**GENOA CHARTER TOWNSHIP  
PLANNING COMMISSION  
PUBLIC HEARING  
APRIL 11, 2022  
6:30 P.M.  
AGENDA**

<b>Attention:</b>	Kelly Van Marter, AICP Planning Director and Assistant Township Manager
<b>Subject:</b>	Bible Baptist Church – Special Land Use and Site Plan Review #3
<b>Location:</b>	3850 Golf Club Road – southwest corner of Latson and Golf Club Roads
<b>Zoning:</b>	LDR Low Density Residential District

At the Township’s request, we have reviewed the revised submittal from Bible Baptist Church requesting special land use and site plan review/approval for a new church and activities within the natural feature setback (site plan dated 3/16/22).

**East Elevation**  
Scale: 1/8" = 1'-0"

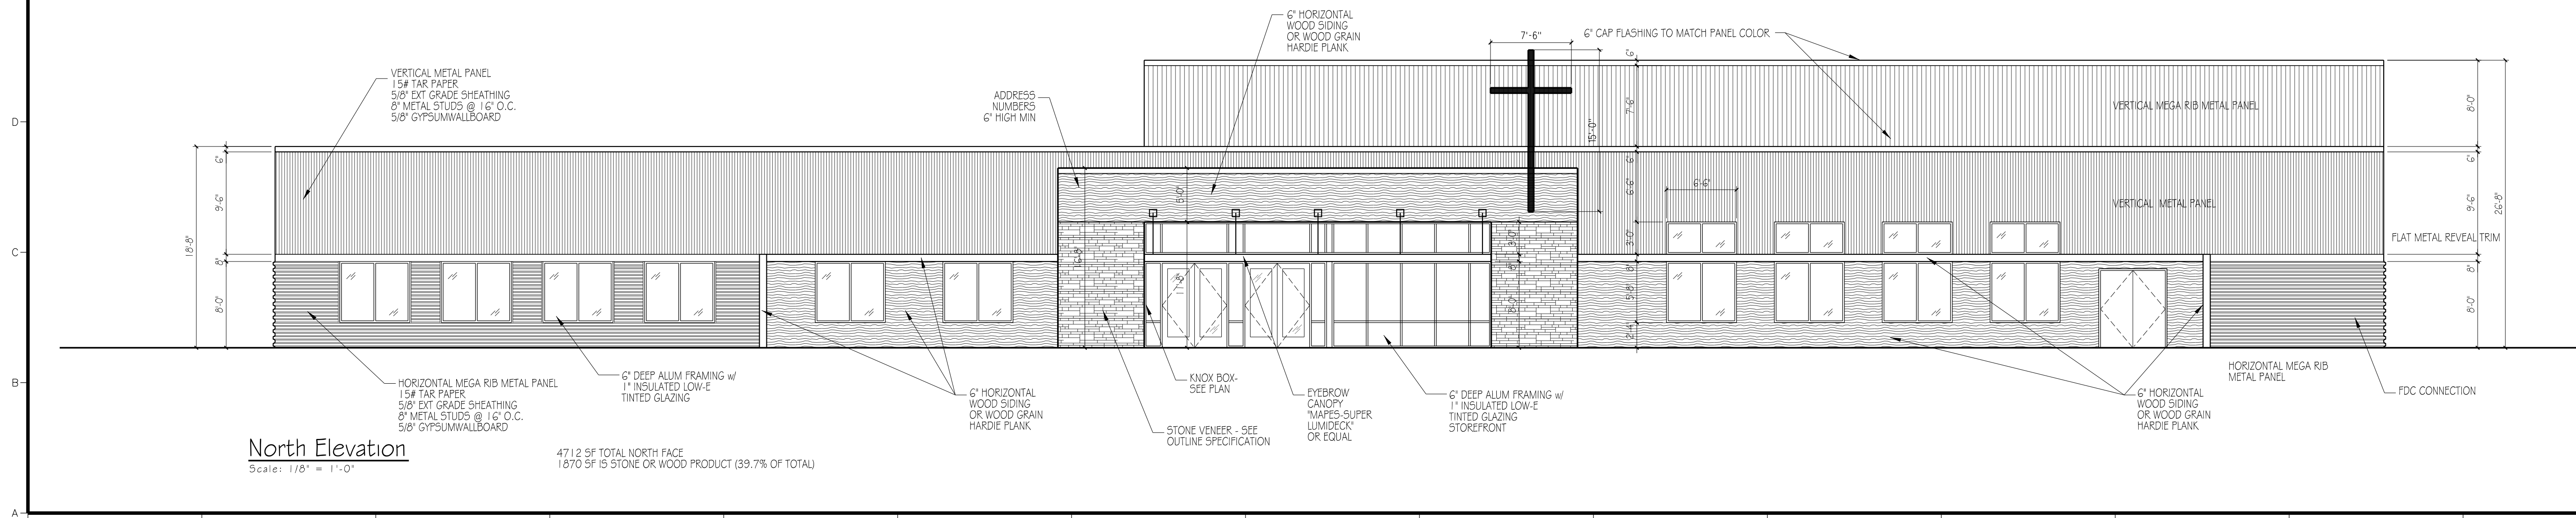
- a. The façade facing Latson Road is comprised simply of metal siding.
- b. In terms of design and materials, the rear façade is not “comparable to the front façade.”
- c. The applicant should be prepared to present building material and color samples (and/or a color rendering) to the Commission.
- d. The Township may allow a performance guarantee in lieu of pathway construction at this time.
- e. The landscape plan is deficient by 2 parking lot trees.
- f. The Planning Commission may allow existing vegetation in lieu of new greenbelt plantings.
